PRODUCT BULLETIN

SUBJECT: UB90-100 Series Boilers - Hot Surface Igniter Change

Fig. 1

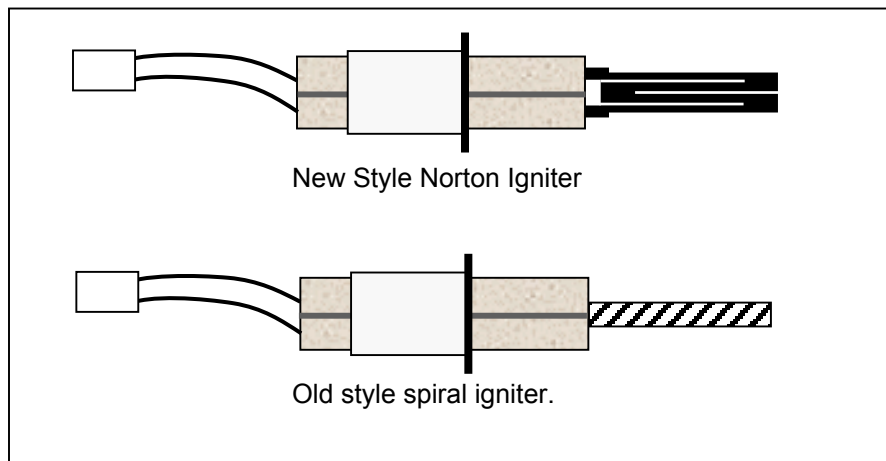
The UB90 50-100 series of boilers are now being manufactured utilizing a Norton brand hot surface igniter. The previously used igniter has been phased out and replaced by the Norton igniter. Both igniters continue to be approved for use with the UB90 50-100 series of boilers and are cross compatible.

The shape (see Fig. 1) of the Norton igniter creates a larger surface area resulting in improved ignition. This is especially helpful for LP gas. The Norton Igniter has also proved to be more robust, increasing igniter life.

The part number for the replacement igniter kit will remain 43800013.
